PERMIT

SEWAGE DISPOSAL SYSTEM

MARYLAND STATE DEPARTMENT OF HEALTH

SUBDIVISION Moosefield ROAD Cherry Tree Dr. LOT 18, blk C

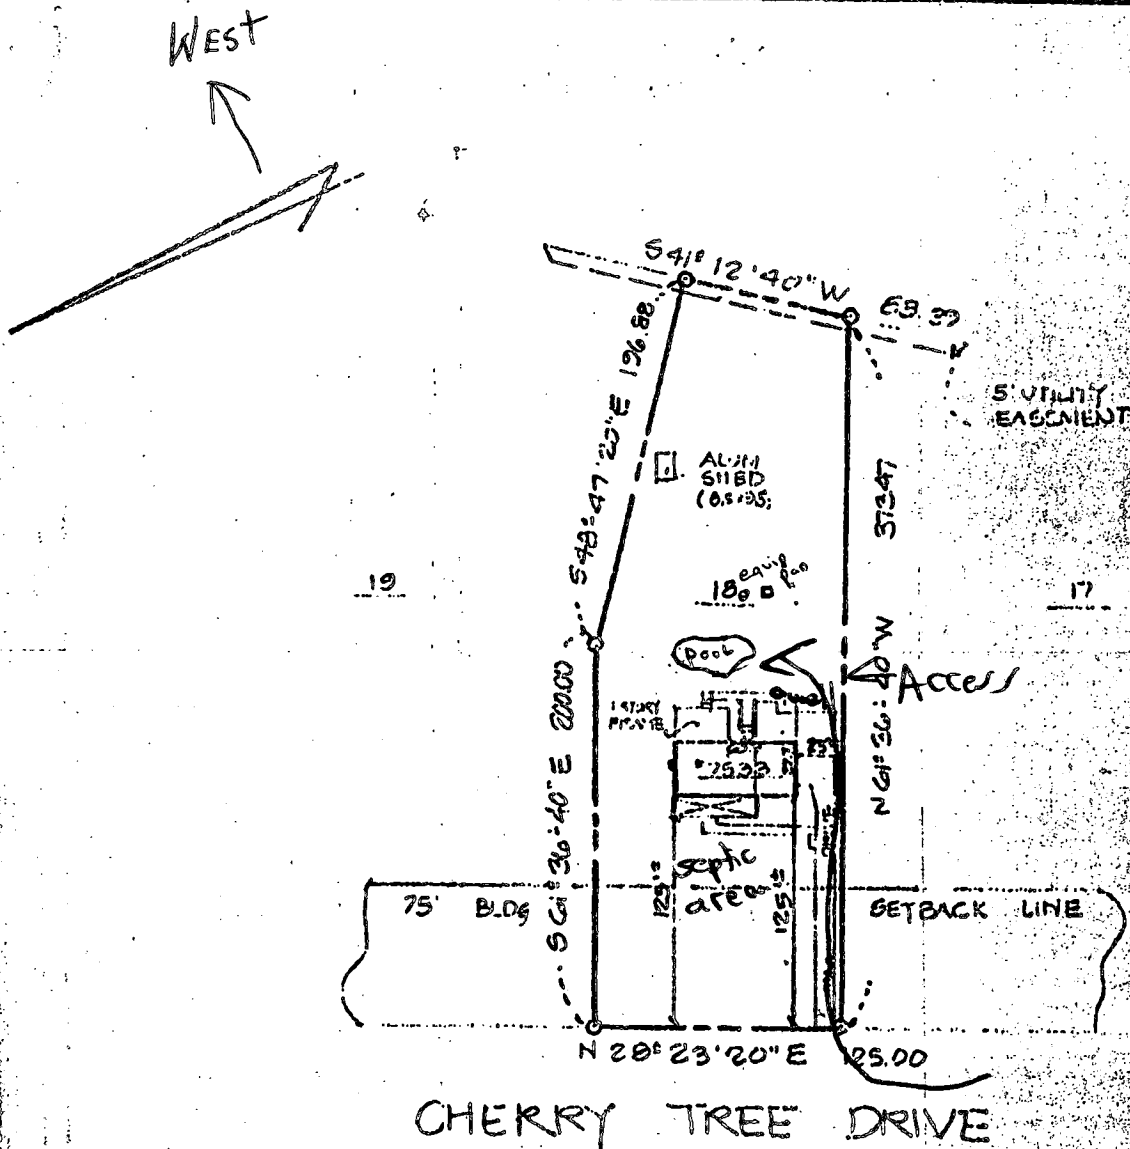
REMARKS *Start about 100 FT. sidewalk area. Latent about 30 FT below original grade. About 1/2 perimeter around dry well has only 1 to 4 units stone. Used steel pipe. JH*

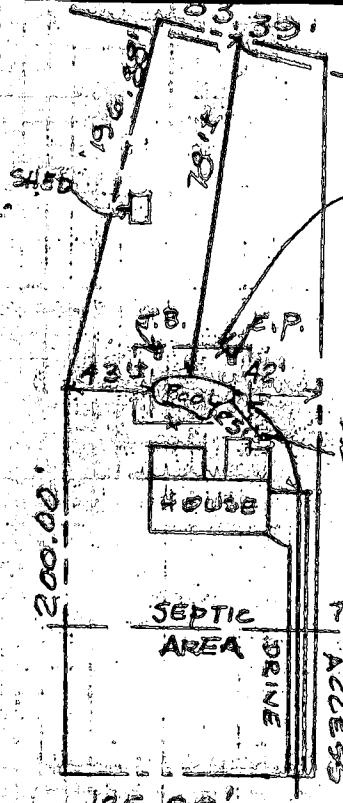
716-97
 POOL PROPOSAL,
 NO IMPACT TO SEPTIC,
 WELL IS CLOSE TO
 HOUSE - SEPERATION
 FROM THE PROPOSED POOL
 TO THE WELL EXCEEDS
 EXISTING SEPERATION TO HOUSE
 OK TO PROCEED.
